Document Title	List of known Issues of Secure Hardware Extensions
Document Owner	AUTOSAR
Document Responsibility	AUTOSAR
Document Identification No	971

List of known Issues of Secure Hardware Extensions

Figure 1: Correction of boot flow chart

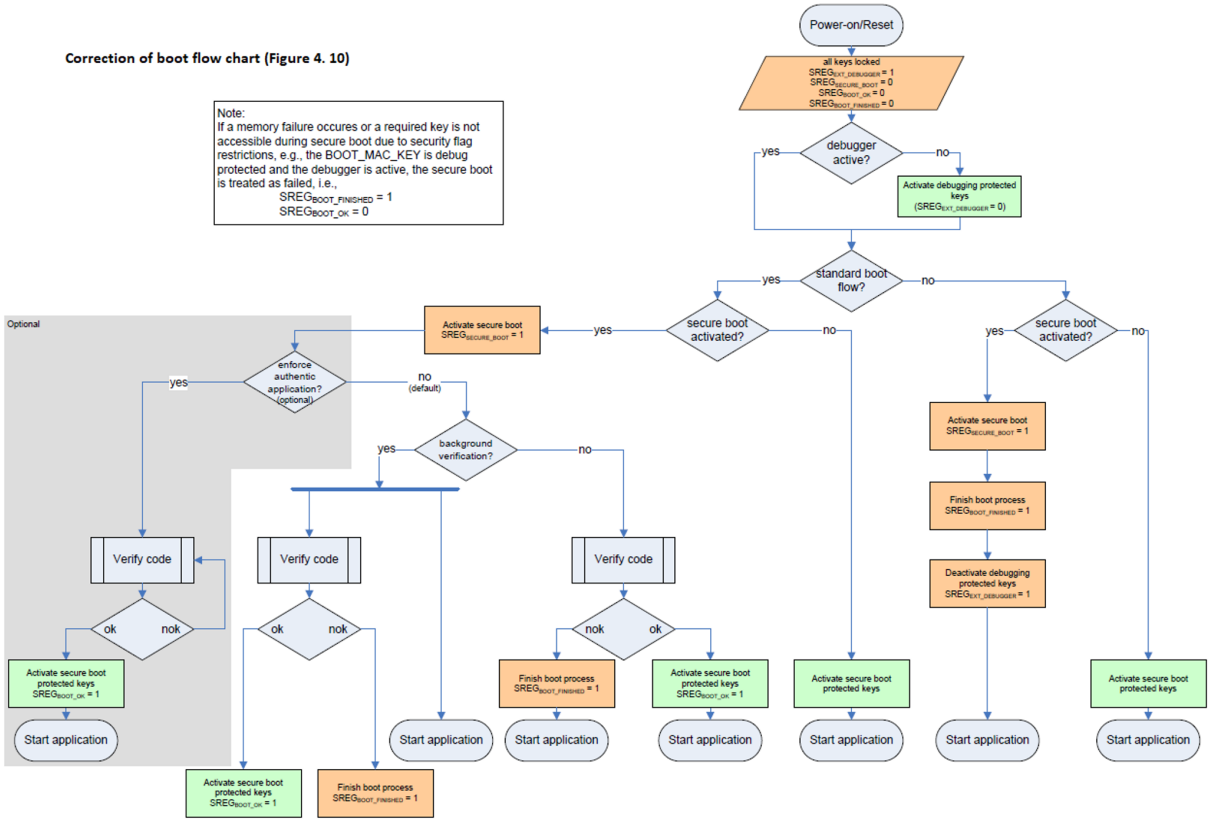
No.	Date	Severity	Problem Description	Location
1	2009-07-31	erratum	CMD_EXPORT_RAM_KEY can also issue error code ERC_KEY_NOT_AVAILABLE. *Note: The description of the command and the overview table were missing the information.*	Section 4.7.9 Table 4.6
2	2009-07-31	erratum	CMD_GET_ID may not issue error code ERC_KEY_NOT_AVAILABLE since key protection flags are not evaluated *Note: The description of the command and the overview table indicate an error code that cannot be emitted by the command.*	Section 4.7.17 Table 4.6
3	2009-07-31	erratum	CMD_EXPORT_RAM_KEY reads UID *Note: The command also needs to access the UID to calculate the messages. The referenced table is missing the corresponding information (X = used by function).*	Table 4.4
4	2009-07-31	erratum	The flag SREG.EXT_DEBUGGER has not to be set if the secure boot failed, see Figure 1 of this errata sheet for a corrected flow chart.	Figure 4.10

5	2009-08-28	detailing	Behavior of secure boot status in power saving modes, e.g., power gating, non-local clock gating etc.: whenever the CPU, a memory or SHE enters a power saving mode, the status register bit SREG.BOOT_OK has to be cleared (Figure 4.10: non-standard boot flow) *Note: The specification defines a non-standard boot flow as every boot method where the secure boot mechanism is not started due to special configurations. This includes boot strap over external interfaces, special reset vectors etc. This issue specifically classifies power down modes as non-standard boot flows, and names the* ▽	Section 4.10
